ORDINANCE 12-01

TO AMEND THE OUTLINE PLAN AND DISTRICT ORDINANCE FOR PARCEL I OF THE WOOLERY PLANNED UNIT DEVELOPMENT (PUD) – Re: 1480 W. Tapp Road (Tommy and Lesli Berry, Petitioners)

BLOOMINGTON PLAN COMMISSION
FIRST HEARING STAFF REPORT
LOCATION: 1800 W. Tapp Road

CASE #: PUD-29-11
DATE: November 7, 2011

PUD-29-11
Site Plan

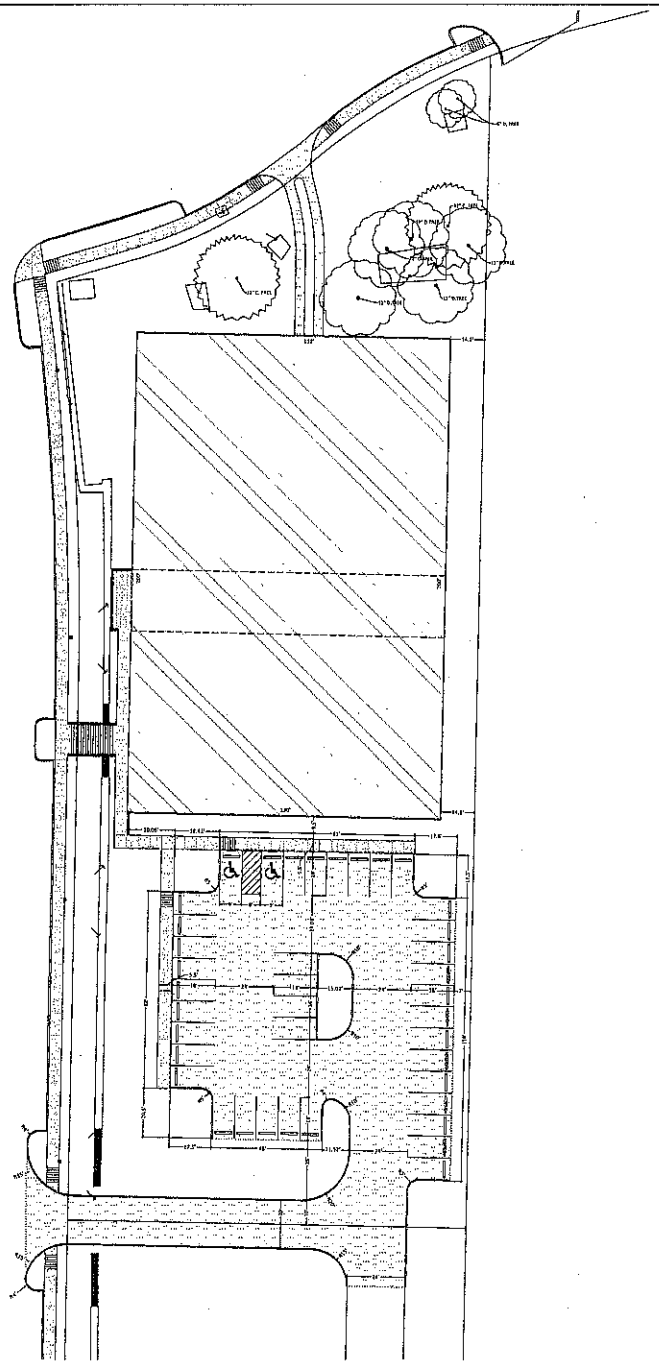
Access: Main access to the site would be from a new drive cut off of Keg Rd. This drive would be shared with a proposed lot to the south, at the corner of Keg Rd. and Tapp Rd. The property is separated from Keg Rd. by a limestone mill

block retaining wall. The new drive and a new pedestrian staircase would necessitate removal of parts of this wall. In addition to the main drive, a secondary Fire Department access drive is shown on the north side of the building with access from Sunstone Dr.

Regardless of whether City Utilities permits the ponds to count toward requirements for water quality, the UDO requires any parking lot of 16 spaces or more to either utilize pervious pavers or natural stormwater filtration (such as bio-swales or rain gardens) to filter parking lot run-off. The petitioners would like the existing Woolery Stone Mill ponds to count toward this requirement also. The Environmental Commission believes this requirement should be met on the site. In general, staff agrees with the Environmental Commission recommendation. Staff is seeking feedback from the Plan Commission on this issue.

Parking: The UDO does not require any parking for this commercial use. The UDO permits a maximum parking for this use of 104 spaces. The petitioners are proposing 39 on-site spaces. Spill-over parking would be handled with a combination of street parking and parking at the Woolery Mill site.

PUD-29-11
Landscaping Plan

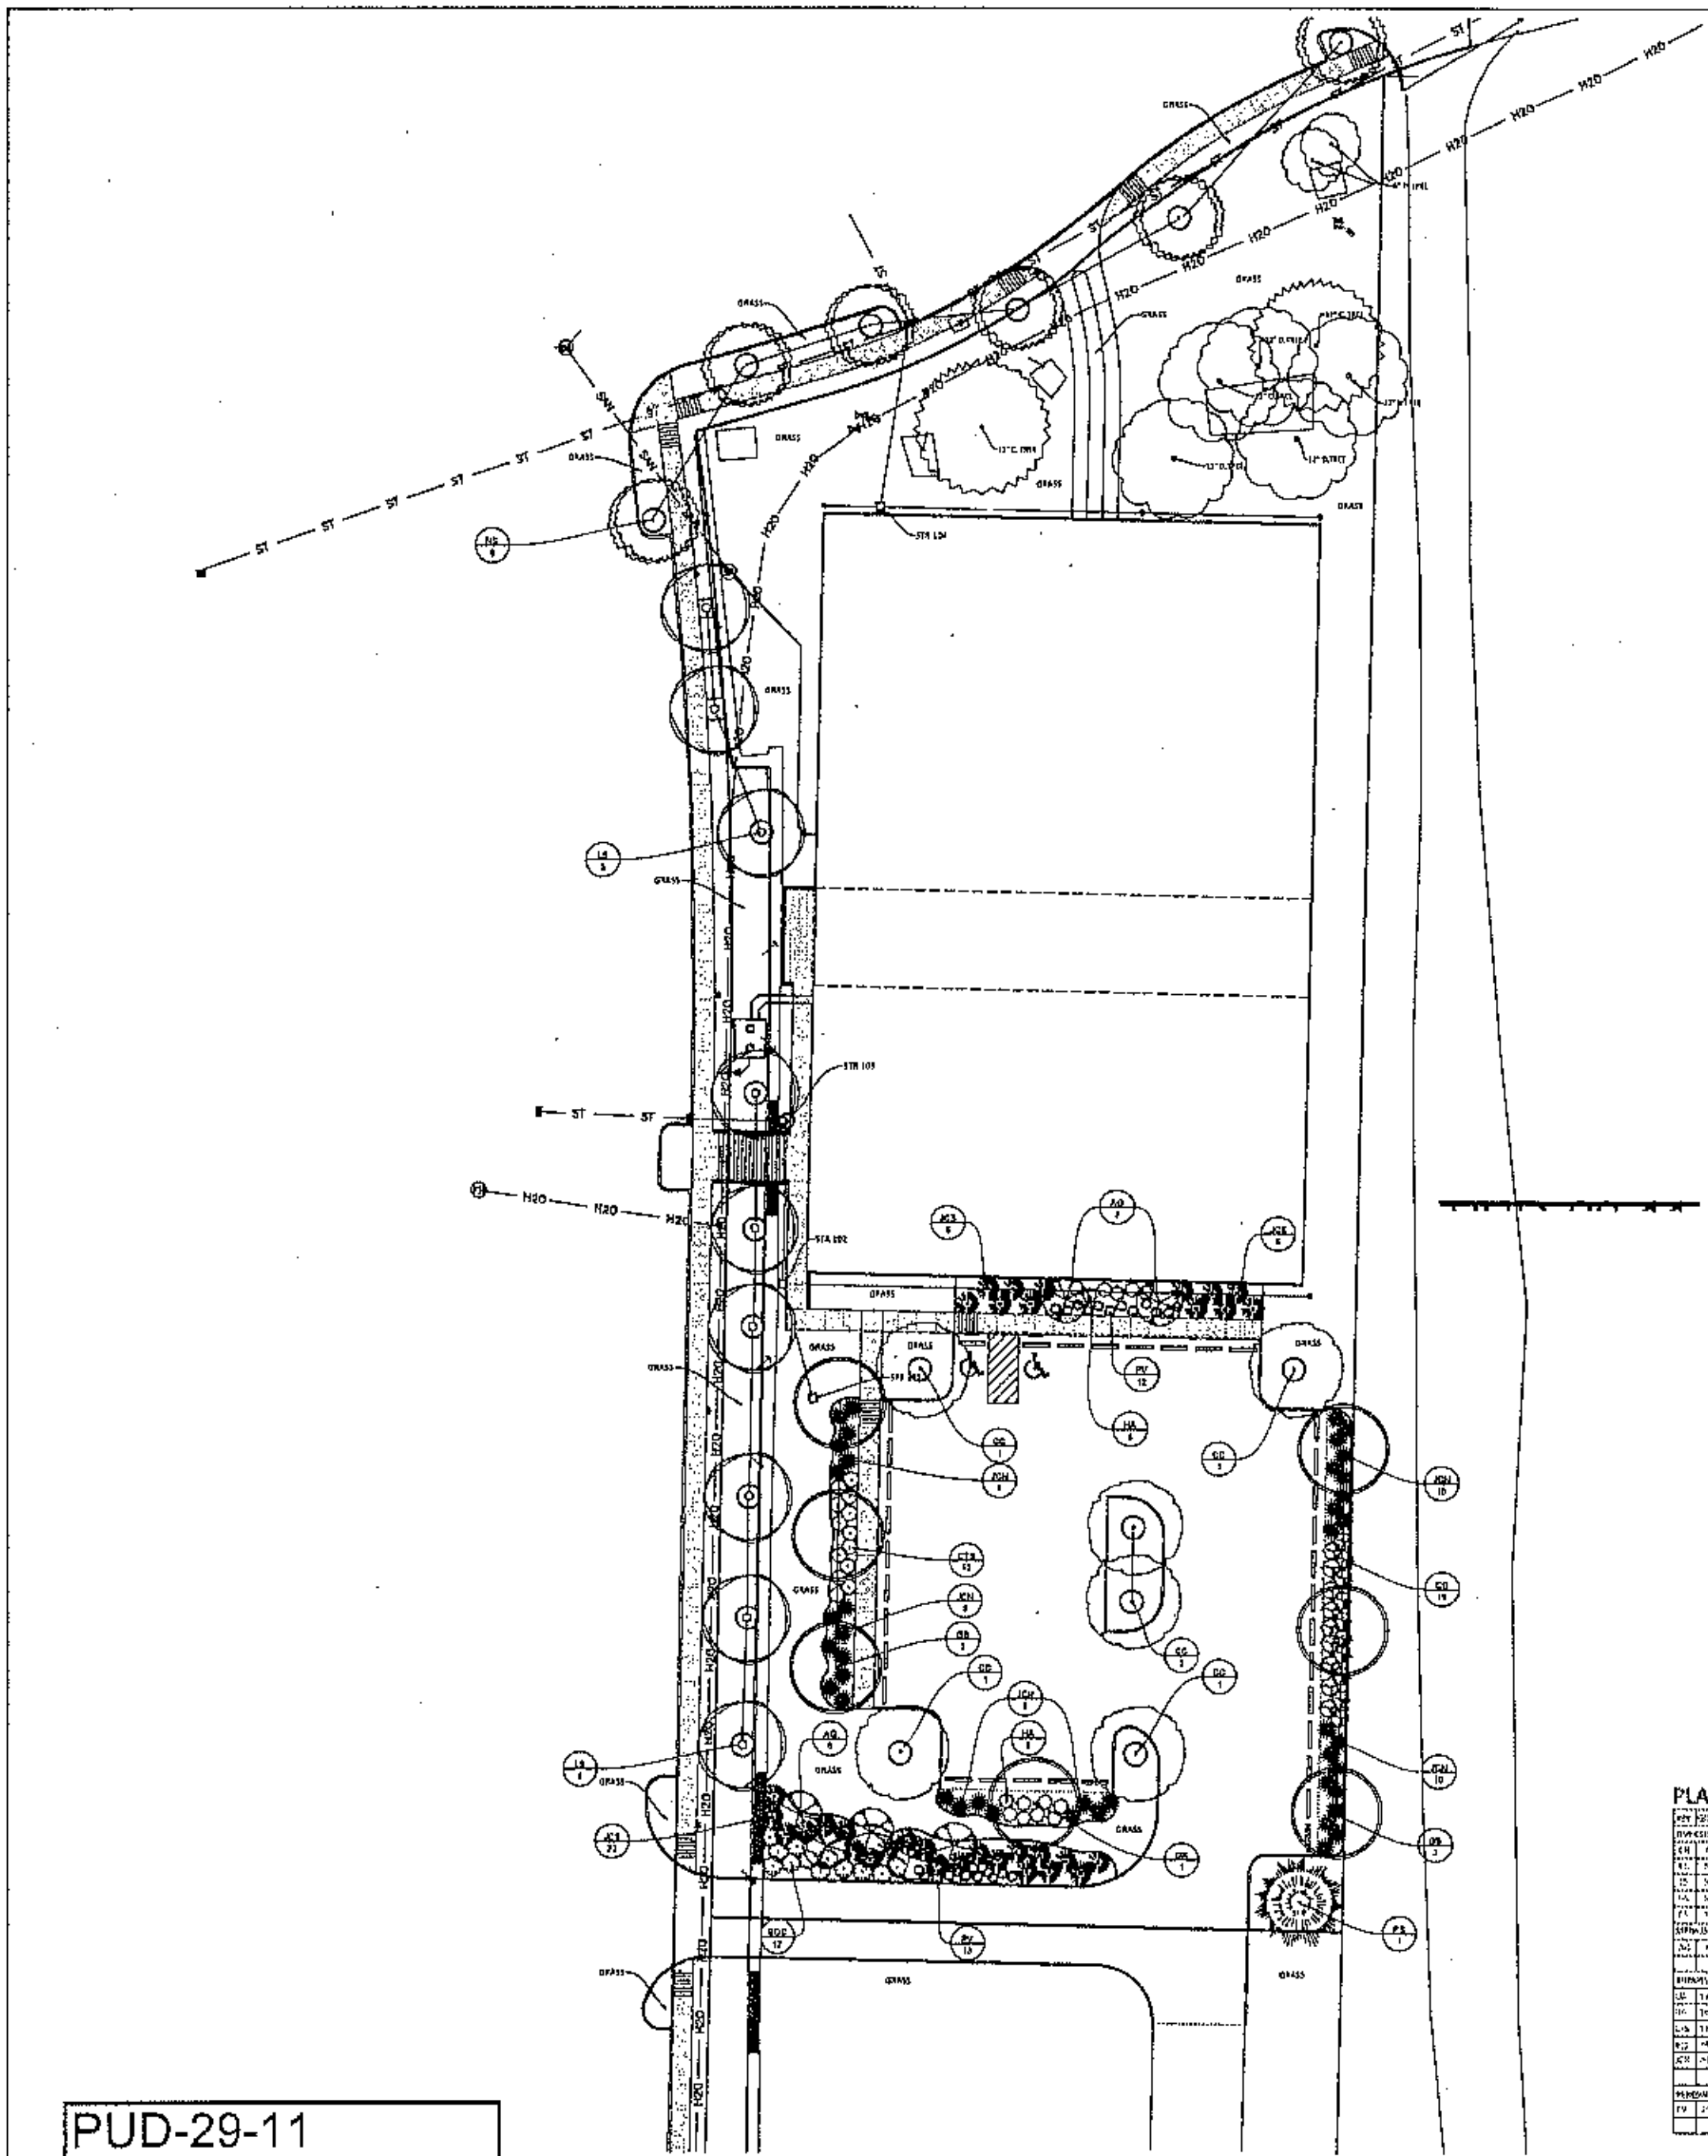
2.) LOW IMPACT DEVELOPMENT:
The EC recommends that the areas north and west of the building, which are planned with traditional landscaping, be re-designed as biofiltration swales. The islands in the parking lot should also be redesigned to be biofiltration swales, thus stormwater from the building and parking lots can be slowed down and filtered before it enters the floodplain as described in UDO 20.05.070 (m) Parking Standards; Surface Material.

2.) The Petitioner should construct bioswales for water quality and quantity north and west of the building and in the parking lot islands.

PUD-29-11
Building Elevations

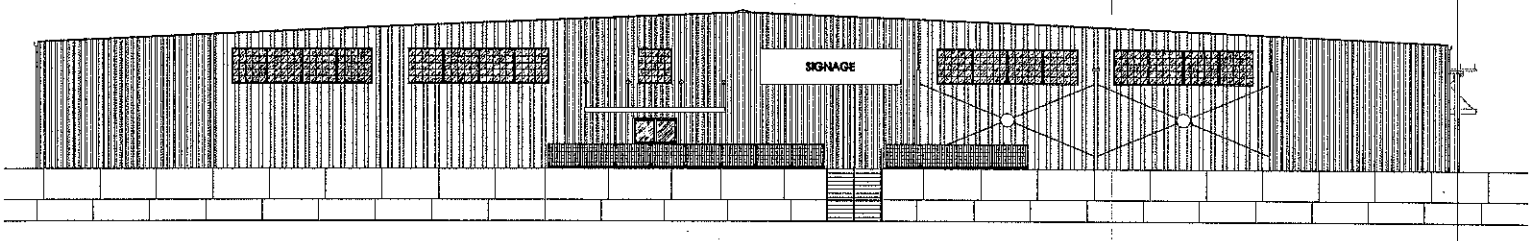
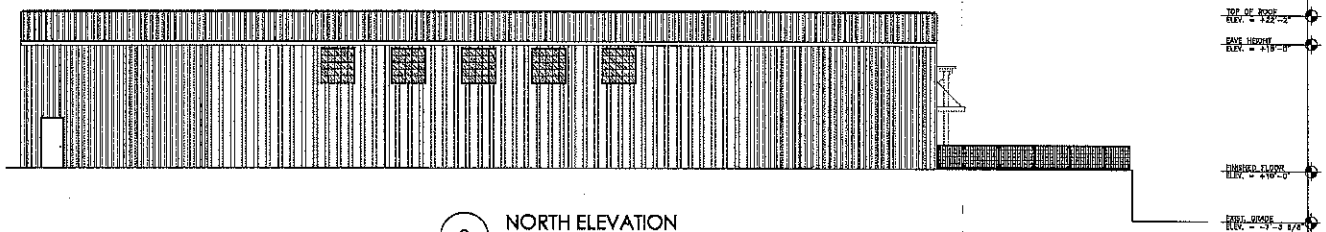
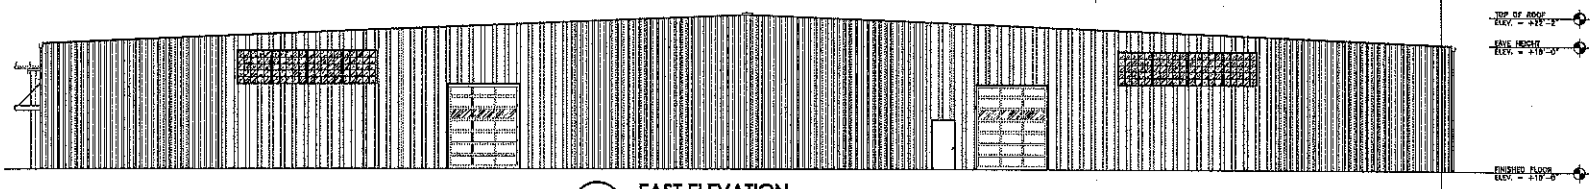
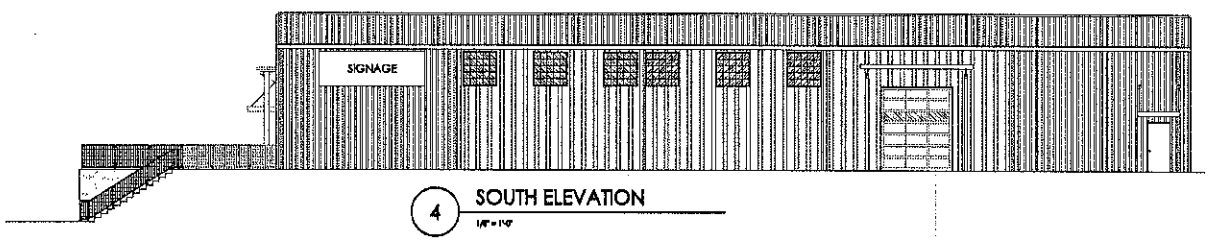
Architecture: The petitioners propose to utilize an industrial aesthetic for the design of the building. The building would have a low-pitched metal roof and would utilize vertical metal siding and windows placed high on the wall. The petitioners' architect designed the building to compliment the former industrial Woolery Stone Mill and the yet to be constructed along Keg Rd. These buildings were 2-3 stories tall and included vertical metal siding, large square windows and little ornamentation.

In addition, the nature of the proposed use may not lend itself well to the architectural requirements of the UDO, especially the requirements for changes in modulation and large windows. Other similar style buildings include the Twin Lakes Recreation Center and the YMCA.

Approval of this PUD amendment, with this architecture, would have to include changes to the Architecture Standards in the UDO. The proposed building violates the following UDO architectural requirements:

1. Materials: Metal siding not permitted
2. Blank wall: Areas of blank wall greater than 40 feet not permitted
3. Patterns: Changes in color and texture required and not provided
4. Roofing: Parapet or roof eaves required and not provided
5. Entrances: Incomplete pedestrian entry detailing

Additionally, a metal pole-barn building is generally considered neither attractive or energy efficient. The EC would encourage the developer to re-design the building to fit better with the esthetics of the surrounding area rather than distract from the unique picturesque look of the rest of the PUD.

With this PUD amendment, the Plan Commission also approved changes to the Architecture Standards in the UDO. The proposed building can be built as depicted and would not have to meet UDO standards for materials, blank wall control, roofing style and entrance detailing.
